## McClellan Air Force Base

Basewide Groundwater Operable Unit

# Groundwater Operable Unit Remedial Investigation/ Feasibility Study Report

**SUBJECT:** Groundwater (GW) Operable Unit (OU) Final Remedial Investigation/Feasibility Study (RI/FS) Document

**FIGURE E-9  
MONITORING AND EXTRACTION  
WELL LOCATIONS**

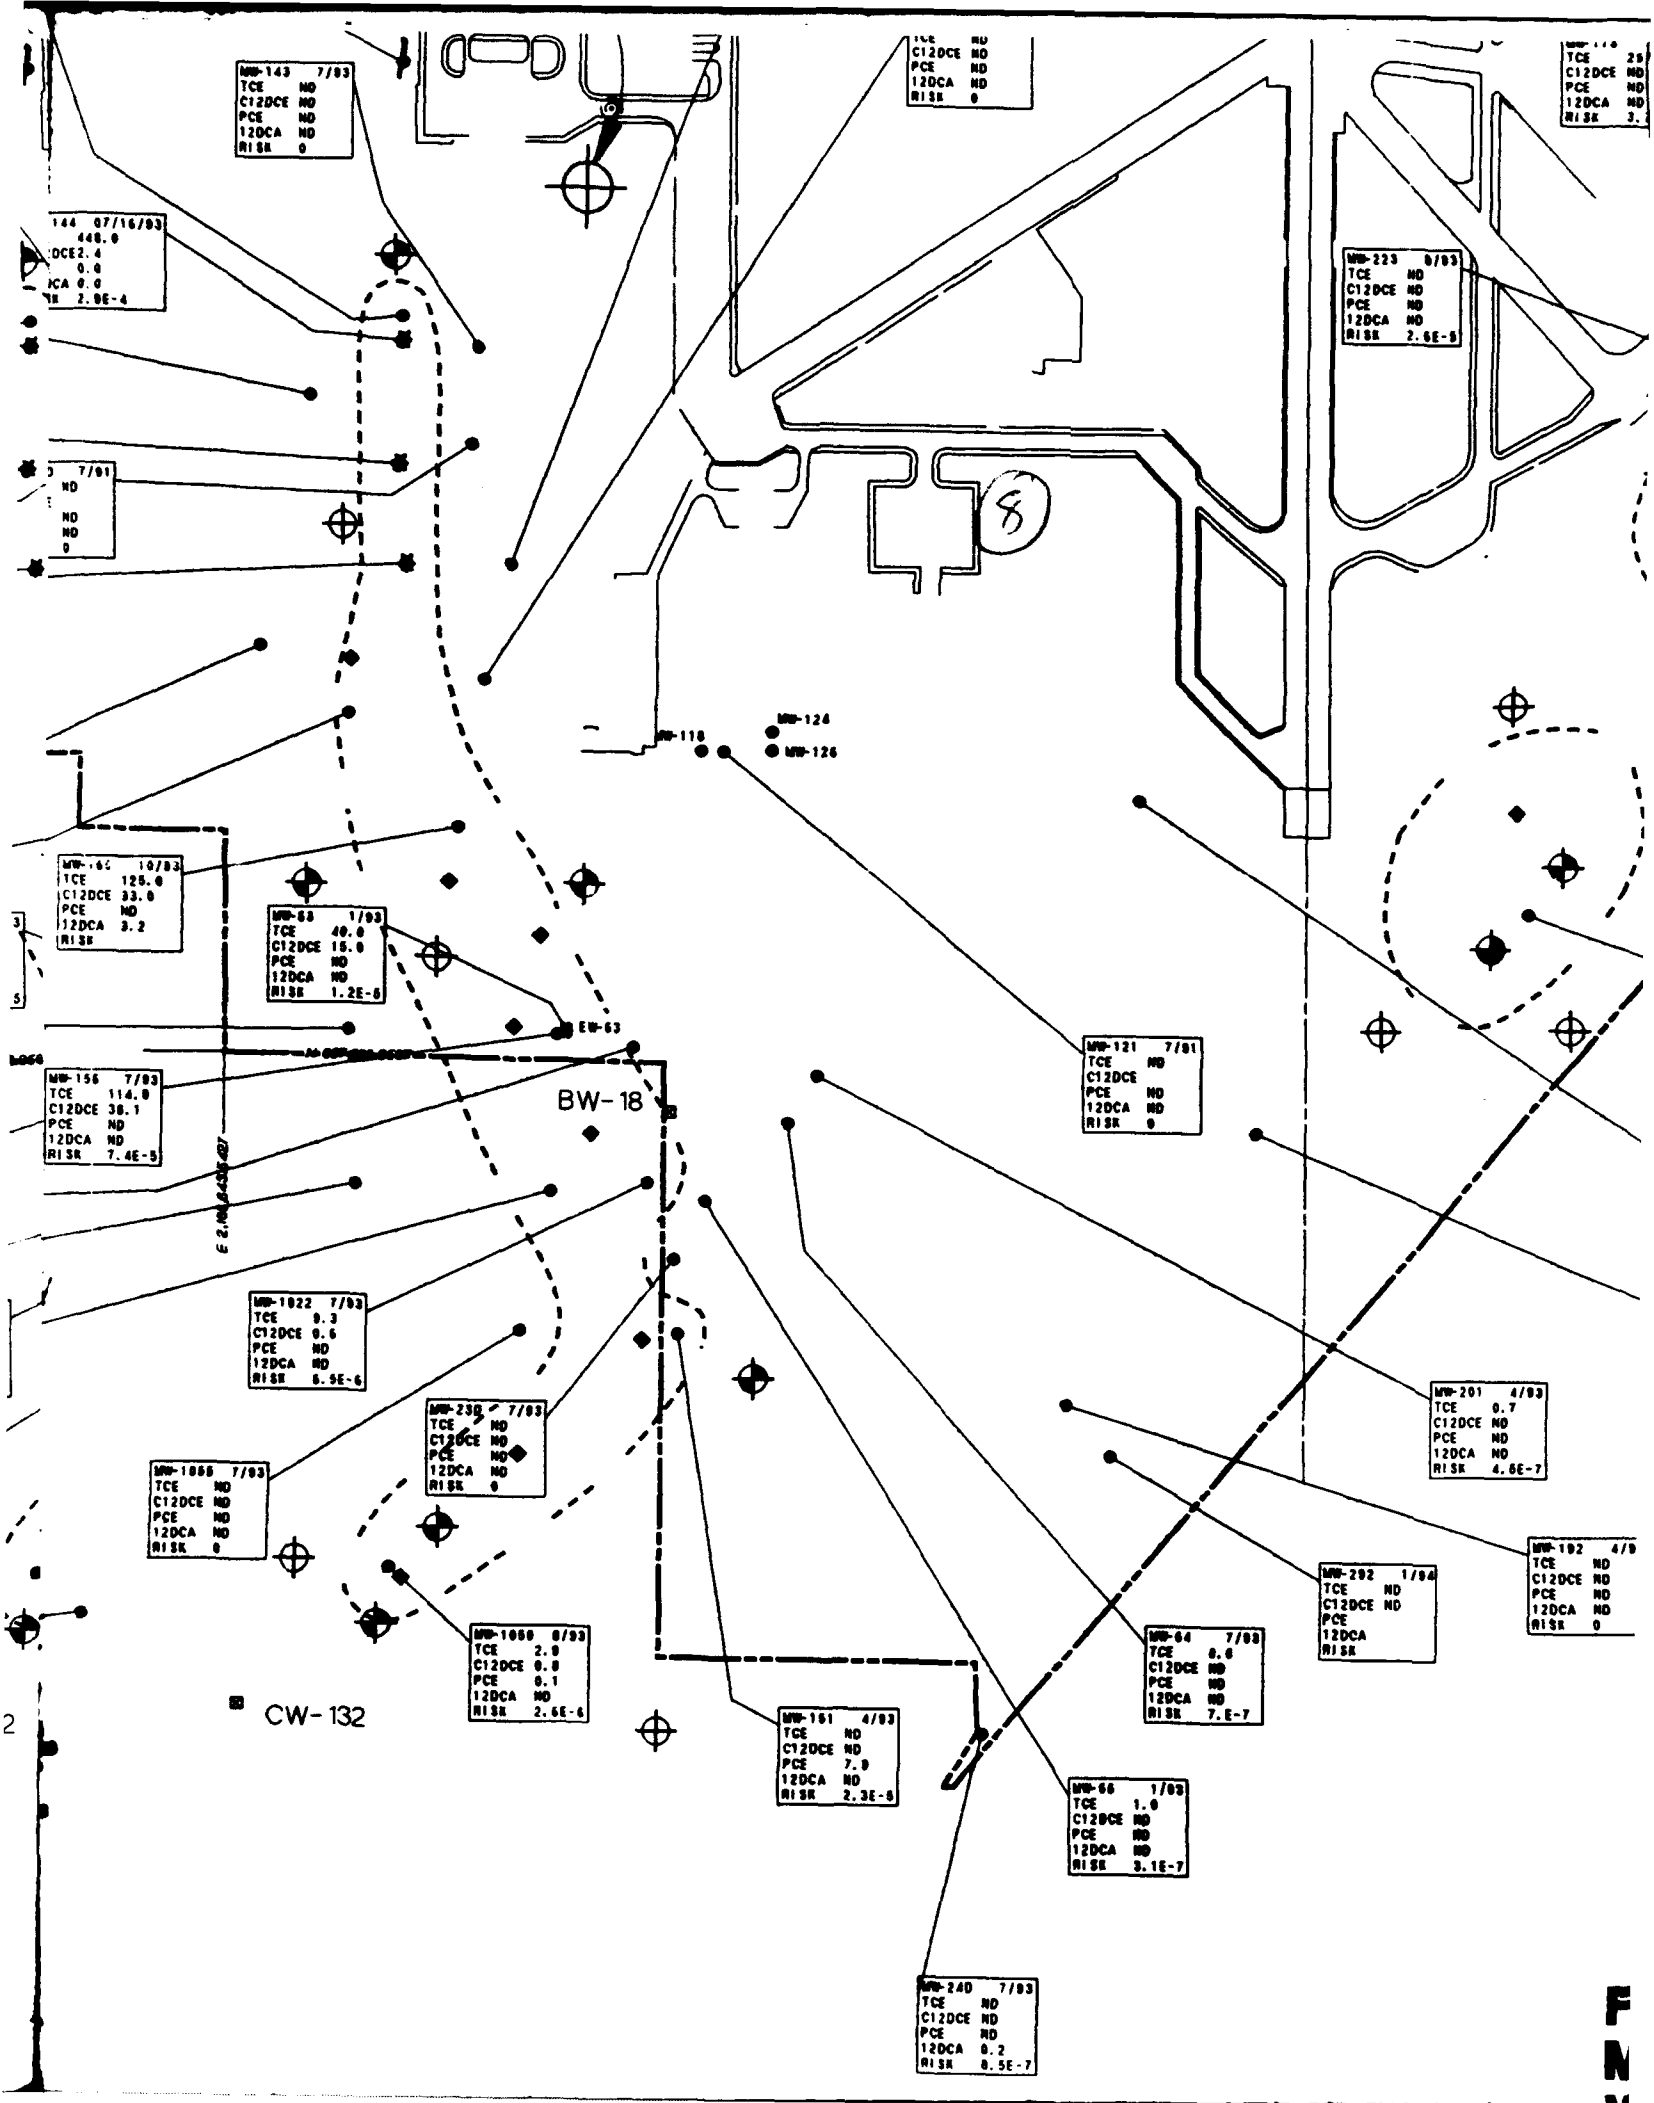
**Figures E-8 and E-9. The text described the need to monitor between the A and B zones in OU-C. Neither figure proposes additional wells suggested by the text. The figures do not indicate additional wells to further define the plume emanating from OU-C1 in the B zone. The maps do not identify the OU-B EE/CA wells, or indicate the need for extraction wells around the OU-B base perimeter to prevent off-base migration when BW-18 is decommissioned.**

**FIGURE F-1**  
**PROJECT INFORMATION FLOW**  
GROUNDWATER OPERABLE UNIT RIIFS  
McCLELLAN AIR FORCE BASE  
SACRAMENTO, CALIFORNIA

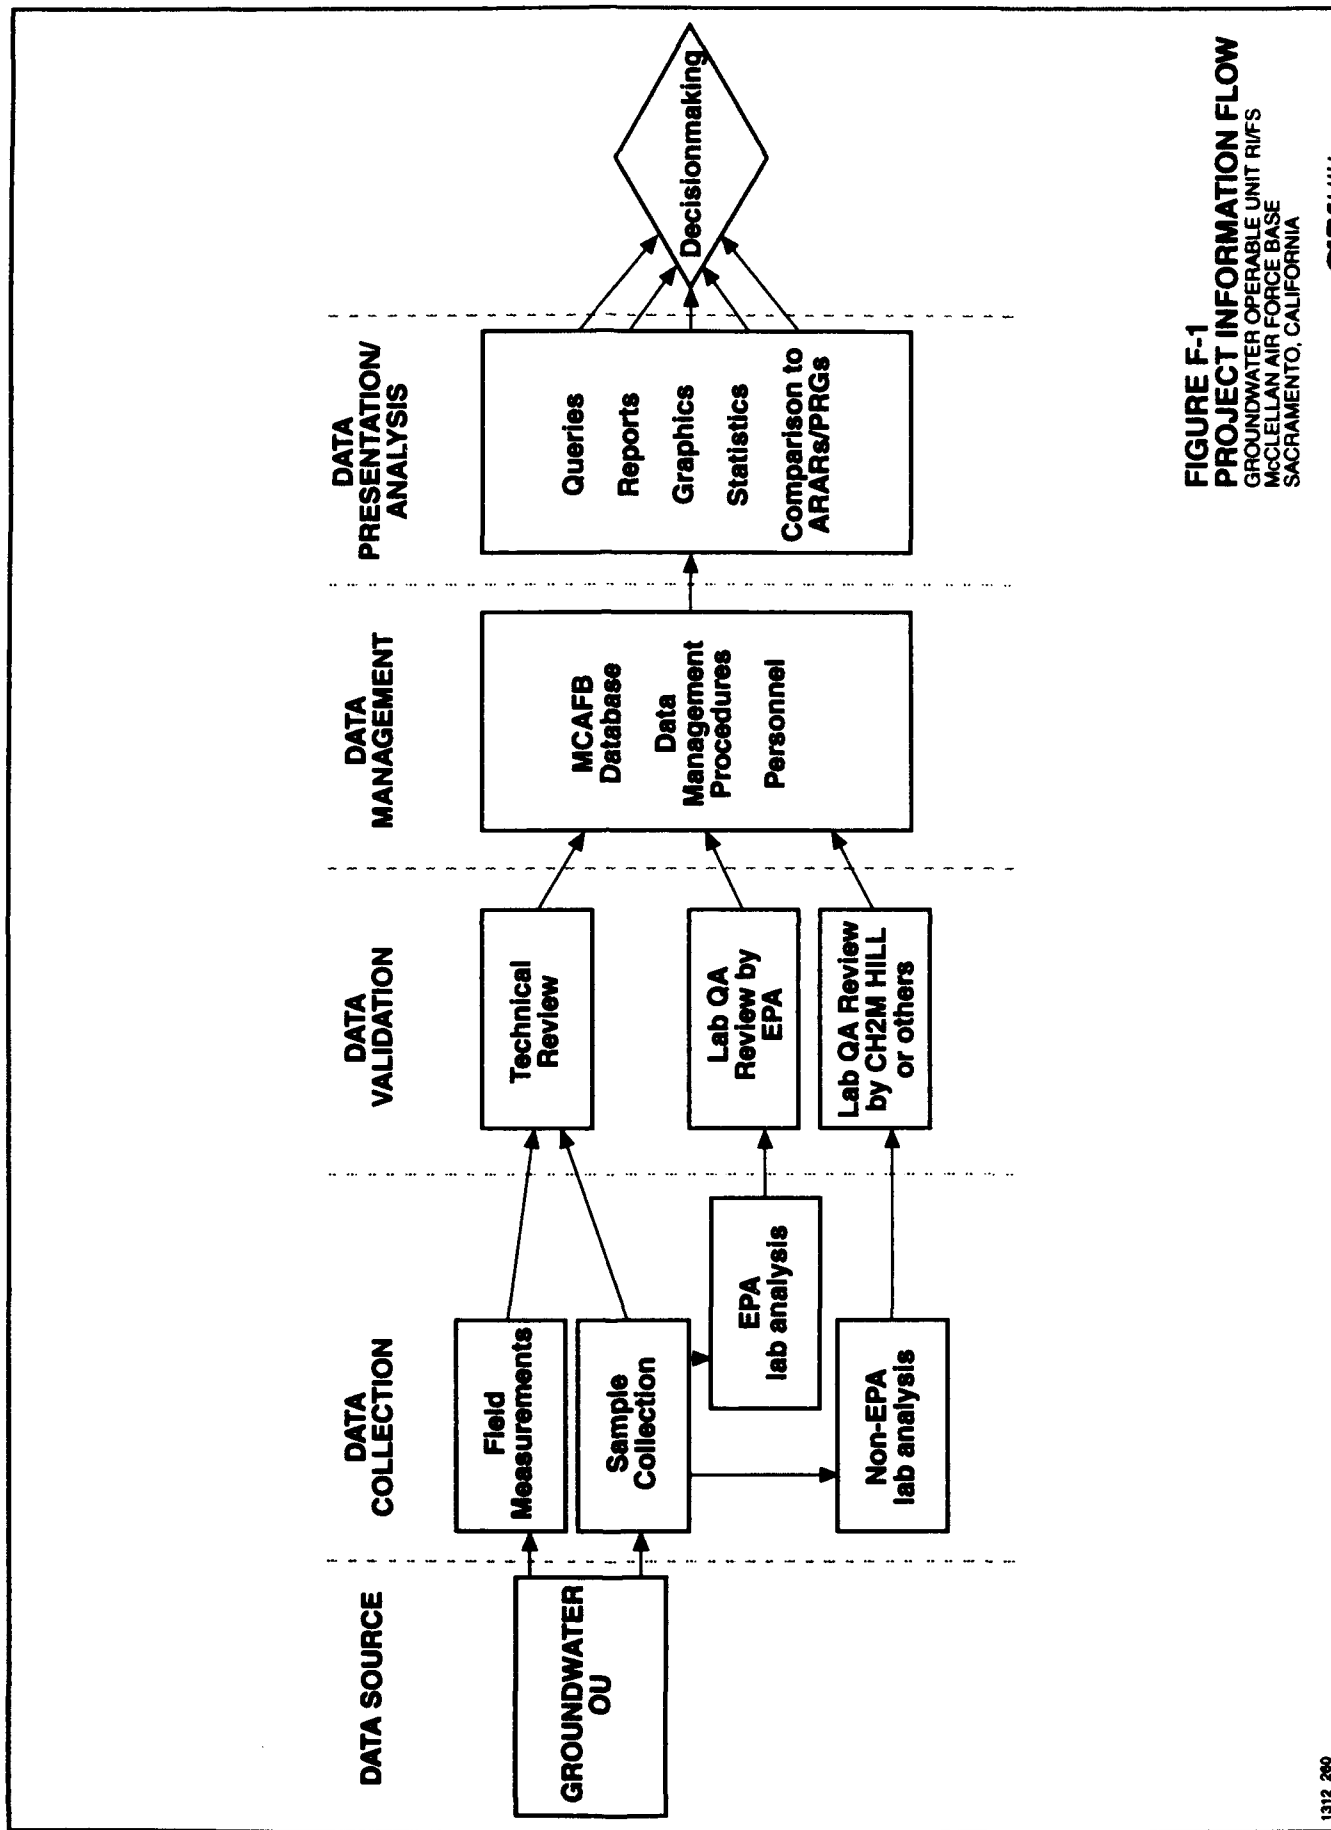
1. **Figure F-1.** The flowchart makes reference to the "Wyckoff OU" and the "Wyckoff Database." These terms are not defined or discussed elsewhere in Appendix F, nor in the rest of the Report. The Report should provide appropriate definition of these terms.
